WATER PERMIT NO. 6639-3

CENTERVILLE DAM DAM RECONSTRUCTION

TO: Jeff Peters, PE, Division of Administration, SD Game Fish & Parks
FROM: Len Neugebauer, PE/LS *Len Neugebauer*
DATE: September 15, 2005
RE: Hydraulic Review and Comments on Preliminary Plans (DGR#648181, Centerville Dam)

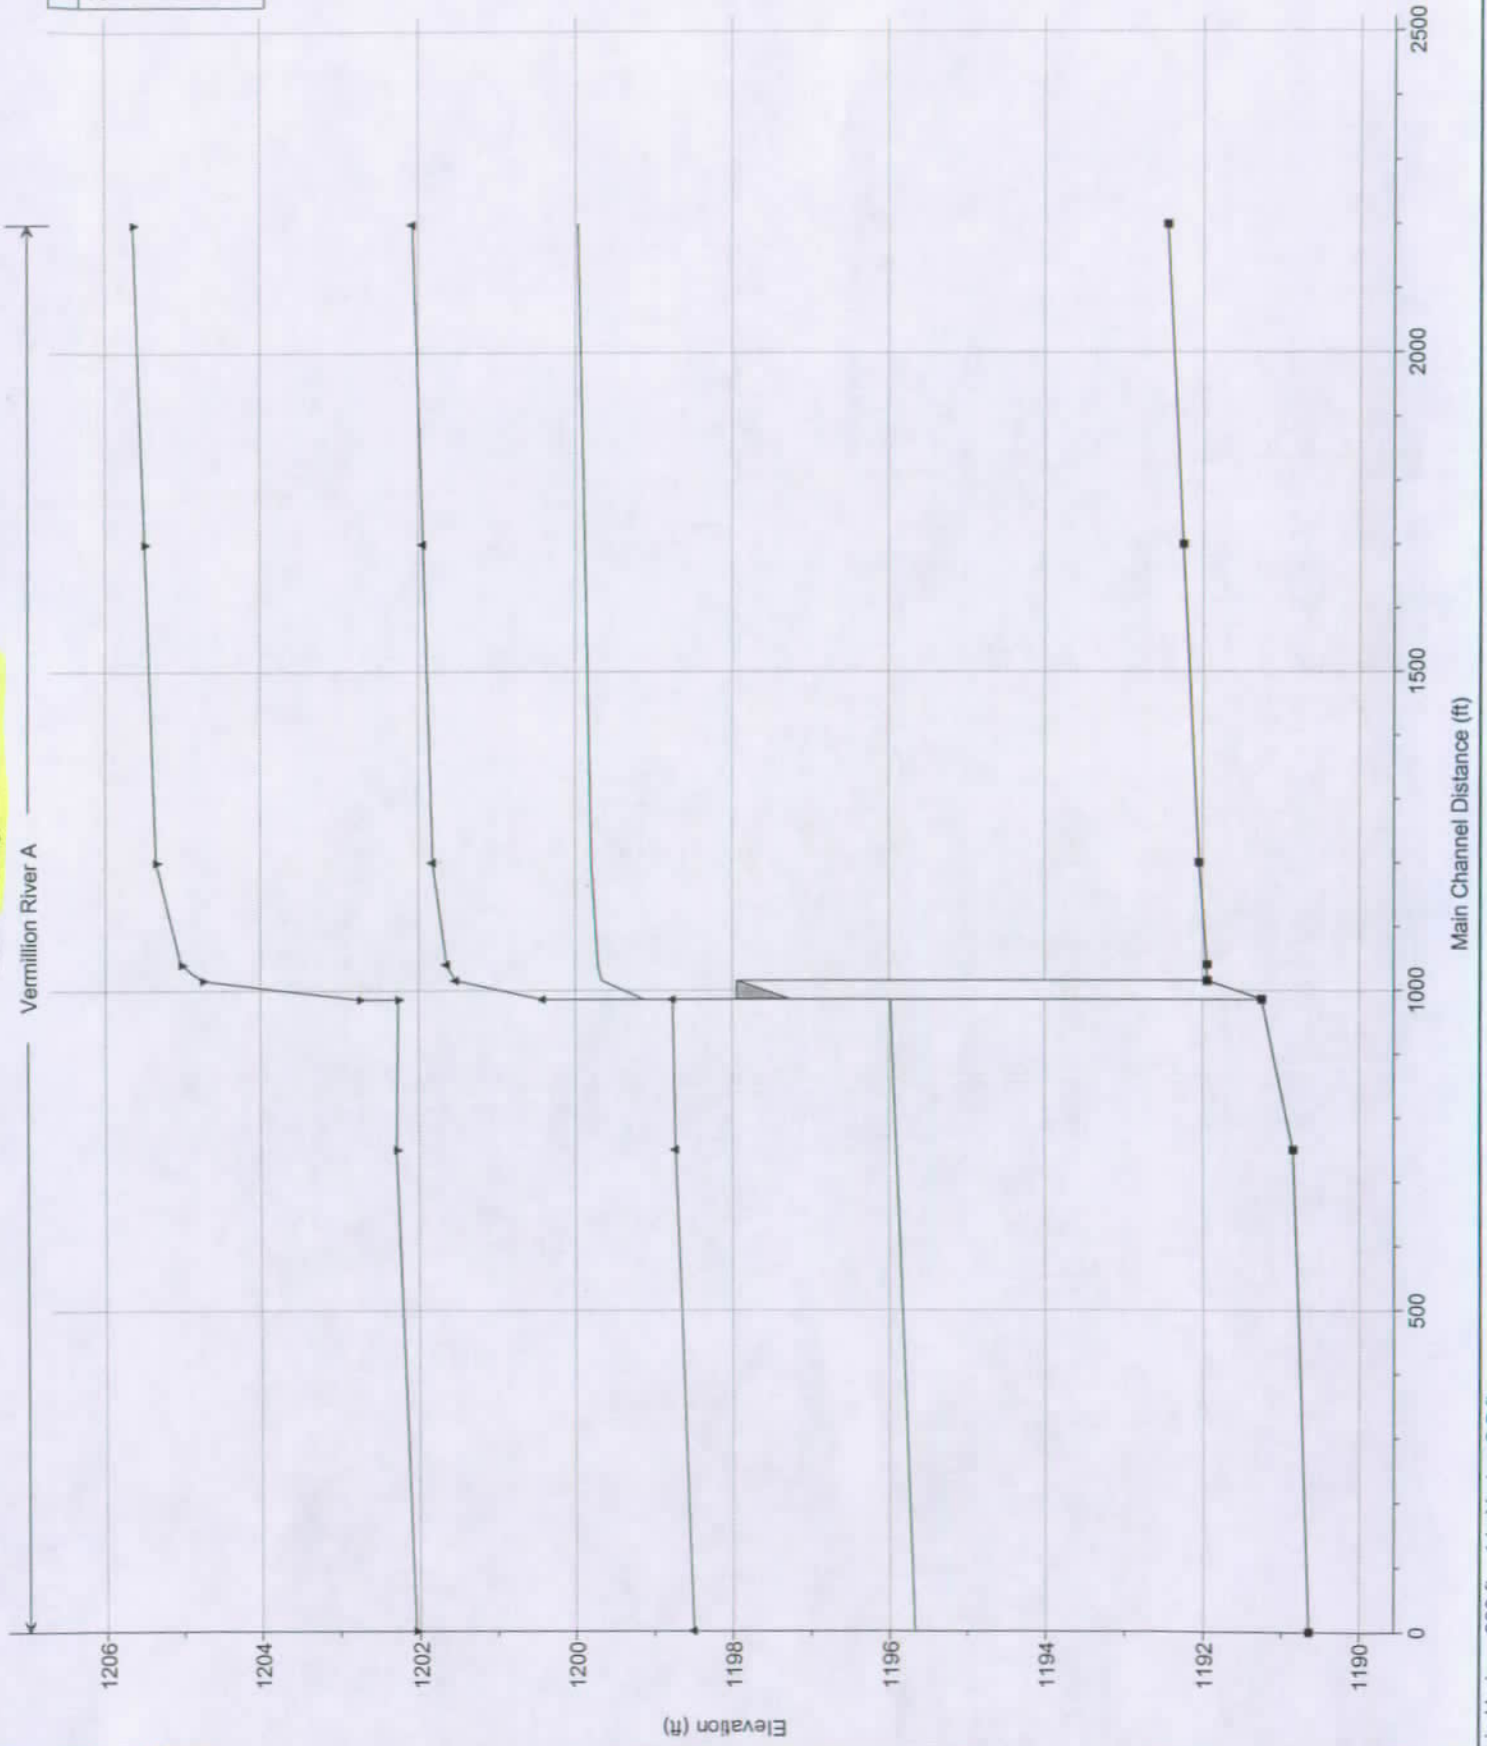
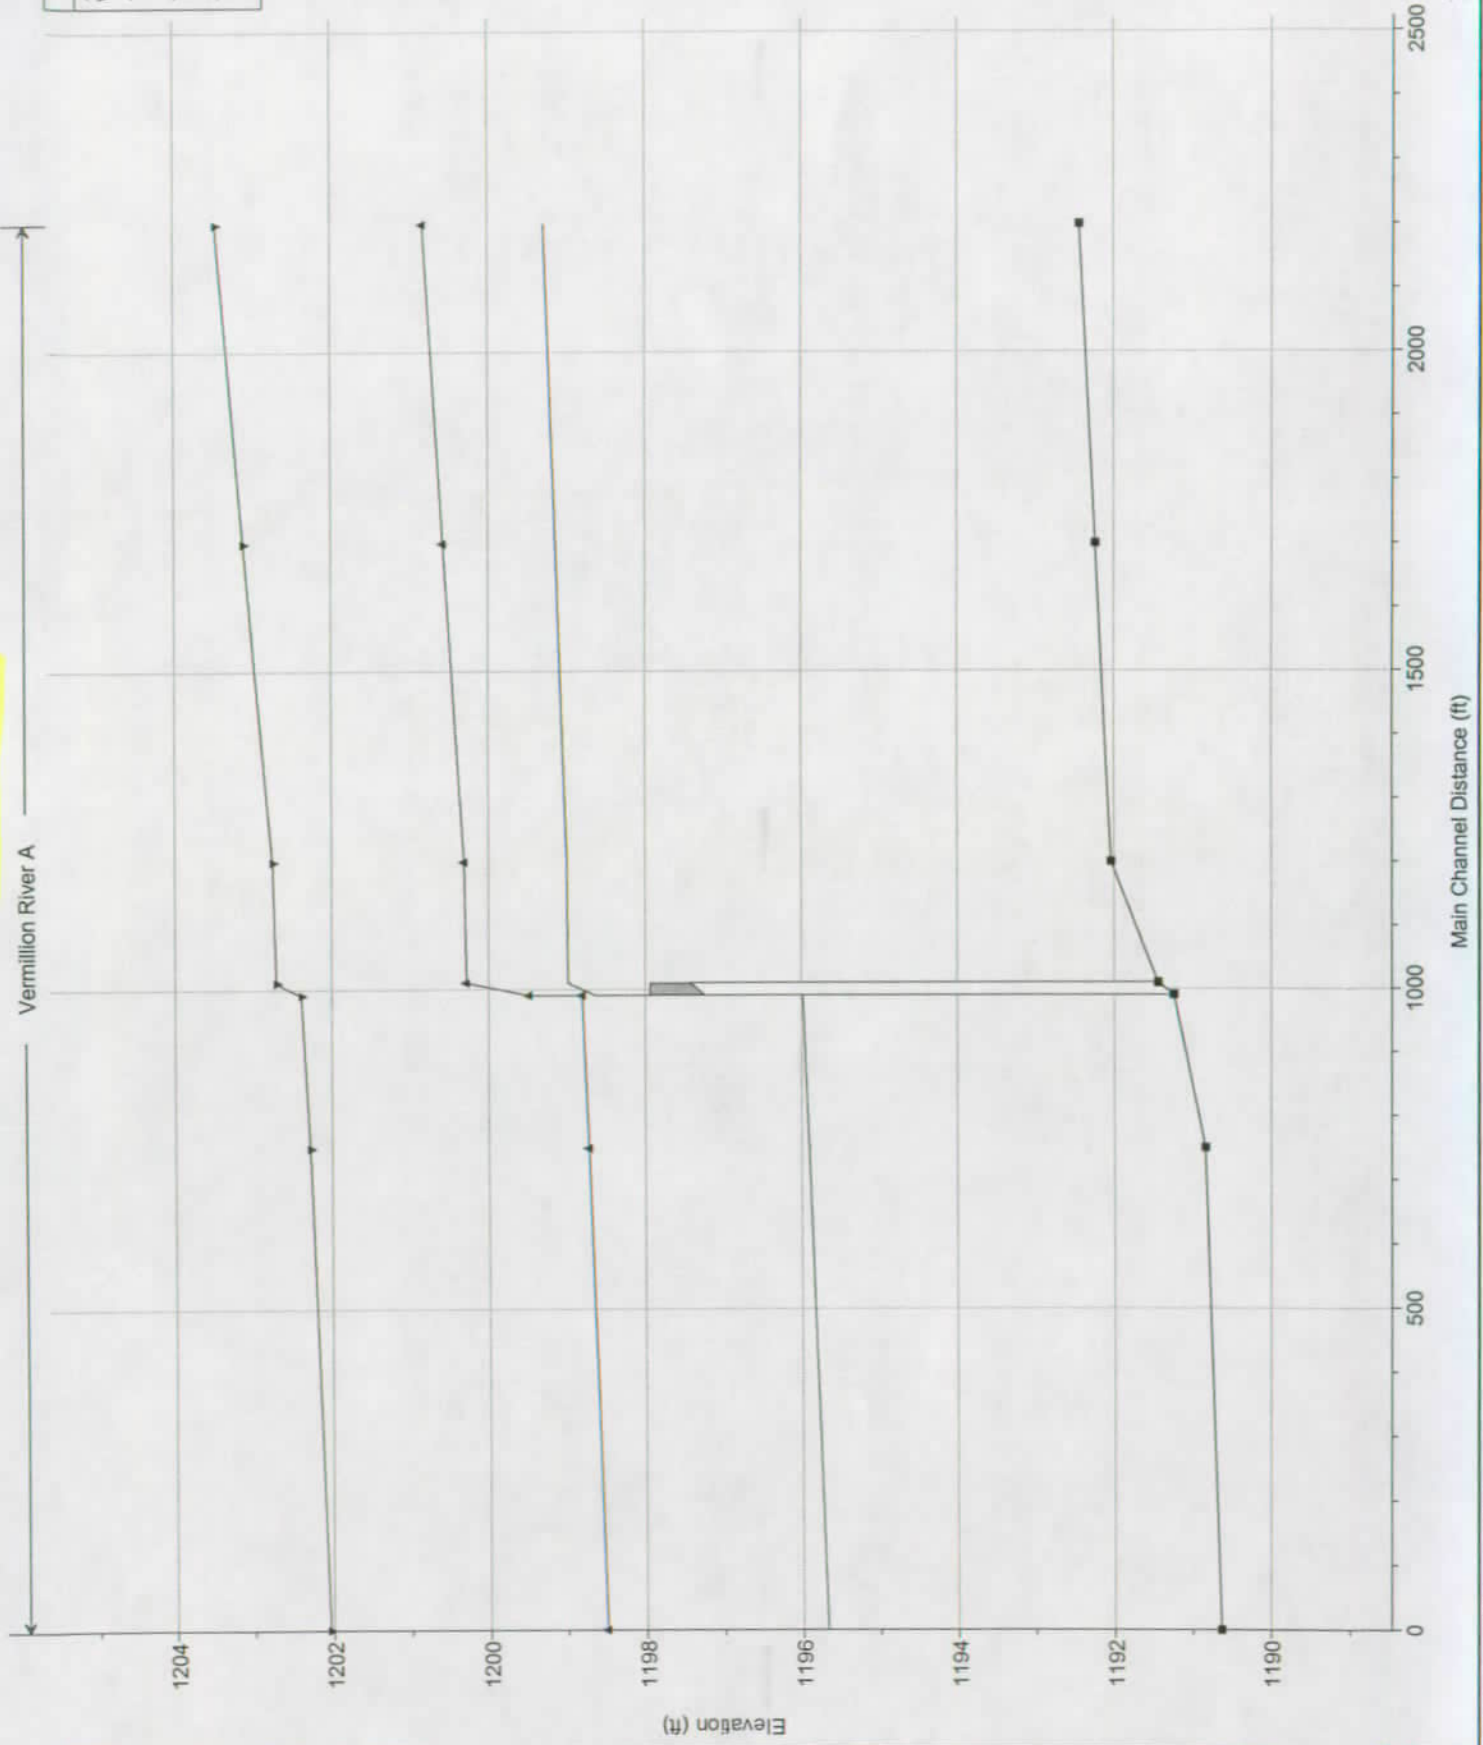
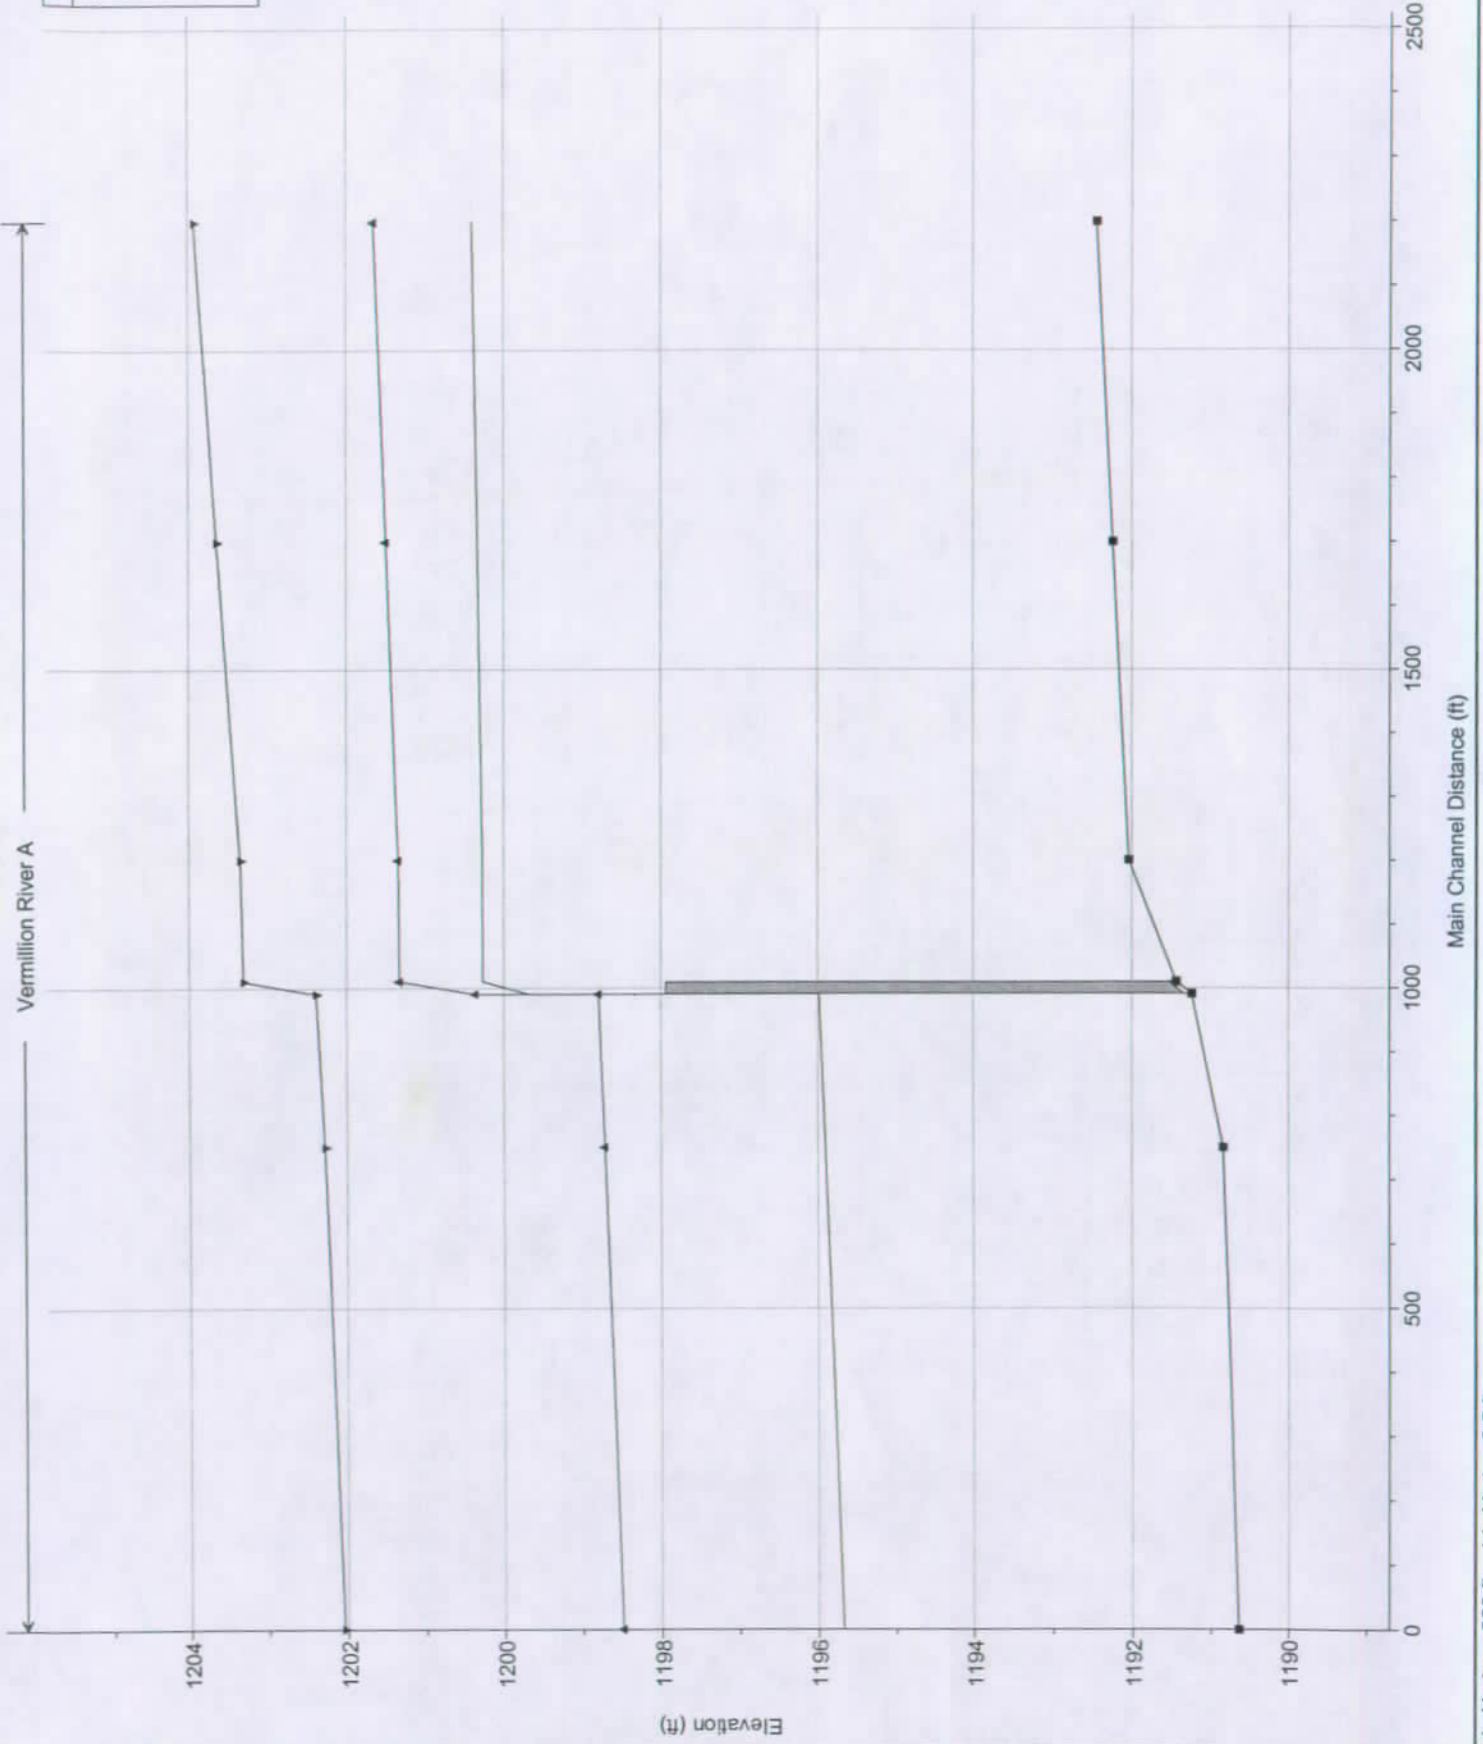
- A. Existing 70' spillway @1198 and existing gate open (prior to dam breach)
- B. Existing 70' spillway @1198 with 90' spillway extension @1198 and existing gate open (DGR Option 2 in our 1999 report)
- ✓ C. Existing 70' spillway @1198 with 80' spillway extension @1199 and existing gate plugged (This is as shown on your preliminary plans for the Centerville Dam reconstruction)
- D. Existing 70' spillway @1198 with 80' spillway extension @1198 and existing gate plugged (This is your preliminary plan modified for the spillway extension @1198)

The flood profiles show the peak water surface elevations (a plot of the W.S. Elev. data shown in the tables which follow the profile plots) and are self-explanatory. Although the water surface elevations computed for your proposed plan are slightly higher than our elevations for DGR Option 2, I believe these slightly higher elevations are acceptable for this dam reconstruction.
